UNITED STATES PATENT AND TRADEMARK OFFICE

APPLICATION NO.	FILING DATE	FIRST NAMED INVENTOR	ATTORNEY DOCKET NO.	CONFIRMATION NO.
10/730,877	12/09/2003	Darren A. Janzig	1023-335US01	4792
28863	7590	06/05/2006	EXAMINER	
SHUMAKER & SIEFFERT, P. A. 8425 SEASONS PARKWAY SUITE 105 ST. PAUL, MN 55125			ALTER, ALYSSA M	
			ART UNIT	PAPER NUMBER
			3762

Office Action Summary

DETAILED ACTION

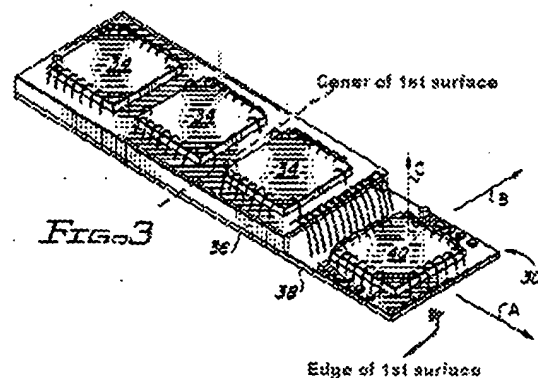
As to claim 1, figure 3 displays “a group of integrated circuits 34, which may be random access memory (RAM) chips, mounted atop a platform 36. Underneath the platform 36 are additional electronic components (not shown) which are mounted to a substrate 38 and which communicate with the integrated circuits 34. An additional integrated circuit 40 is mounted directly to the substrate 38 and is not covered by the

platform 36" (col. 3, lines 19-26). The examiner considers the substrate 38 to be a circuit board.

Since the integrated circuits 34 are mounted on a platform compared to integrated circuit 40, they are in a non-linear profile. Furthermore, the examiner considers the additional electrical components to be discrete components.

As to claim 9, the height of the integrated circuits increase from an edge towards the center. A replication of figure 3 is included and displays the integrated

circuit 40 on the edge of the first surface is at a smaller height than the integrated circuit 34 towards the center of the first surface.

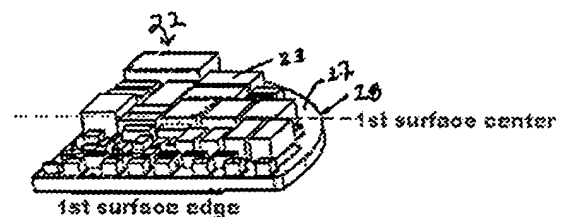
As to claim 9, the height of the integrated circuits increase from an edge towards the center. A replication of a portion of figure 7 is included and displays the integrated circuit on the edge of the first surface is at a smaller height than the integrated circuit towards the center of the first surface.
